Product/Process Change Notification

PCN#	Effective Date	Issue Date
2013-08-01C-01	2013/8/1	2013/8/1
PCN Classification	Product Category	
Minor Changes	DO-27 Package	
Subject		
Forming Dimension Adjustment		
Affected Product(s)		
U-6R Forming Category		
Description of Change(s)		
To avoid secondary processing part on the circuit board		
Content of Change(s)		
Change in Forming Dimension		
Impact(s)		
N/A		
Attachment(s)		
Forming Specification

Reference of Dimension Modification

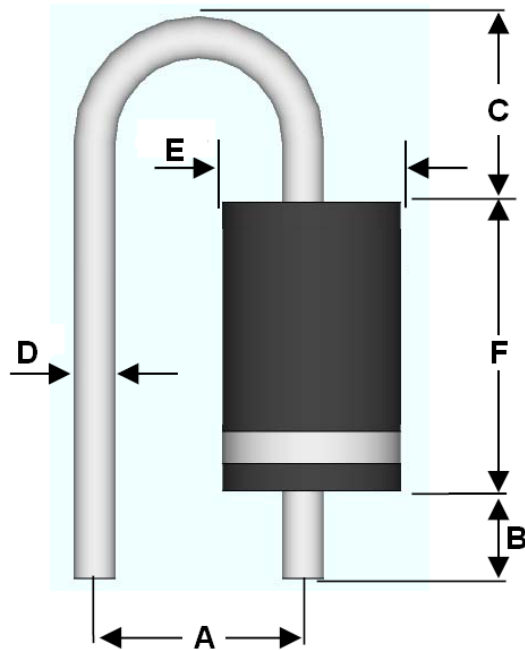
Original Dimension

A: 6.5 ±1.0 mm
 B: 3.7 ±0.4mm
 C: 4.5 ~ 5.3mm
 D: 1.2 ~ 1.3 mm
 E: 4.8 ~ 6.5mm
 F: 7.2 ~ 9.5mm

Modified Dimension

A: 6.5 ±1.0 mm
 B: 3.3 ±0.3mm
 C: 4.5 ~ 5.3mm
 D: 1.2 ~ 1.32 mm
 E: 4.8 ~ 6.5mm
 F: 7.2 ~ 9.5mm
